THE MANITOBA WATER SERVICES BOARD

TOWN OF NIVERVILLE

CONTRACT 1: RAW WATER PIPELINE

ADDENDUM NO. 1

1 TYPICAL DETAIL 1:25
 WELL PUMP

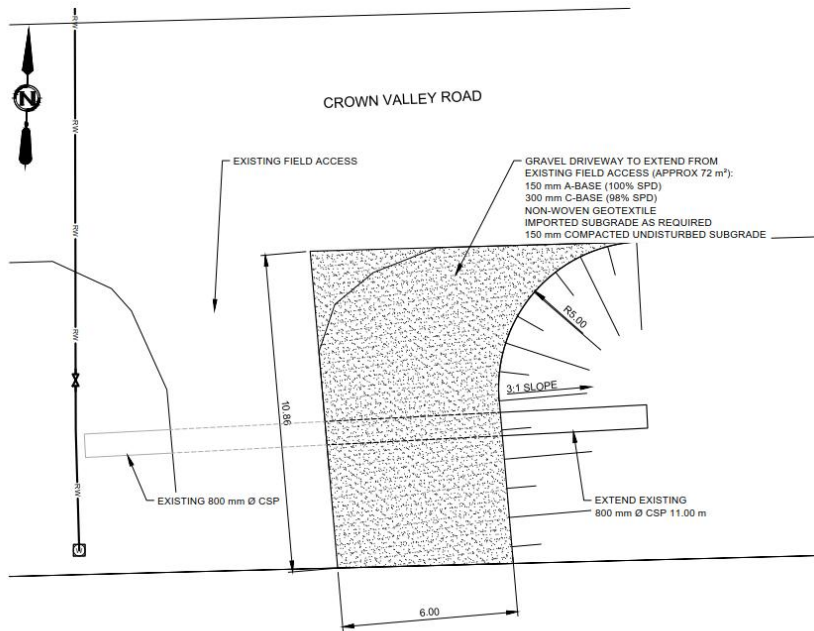
1.3 DRAWING 4977-00-C-501

.1 Replace Typical Detail 1 - Well Pump, with the following:

WELL PUMP INFORMATION		
WELL	WILLOW RIDGE ROAD - NORTH WELL #1	CROWNVALLEY ROAD - SOUTH WELL #2
CASING SIZE	300 mm (EXISTING)	300 mm (EXISTING)
PITLESS UNIT SIZE	300 mm (THIS CONTRACT)	300 mm (THIS CONTRACT)
WELL PUMP DROP PIPE SIZE:	200 mm	200 mm
TYPE:	SCH40 STAINLESS STEEL (BY OTHERS)	SCH40 STAINLESS STEEL (BY OTHERS)
WELL PUMP SET DEPTH (FROM GRADE)	20 m (BY OTHERS)	20 m (BY OTHERS)
NEW PUMP	SEE SPECIFICATIONS (BY OTHERS)	SEE SPECIFICATIONS (BY OTHERS)
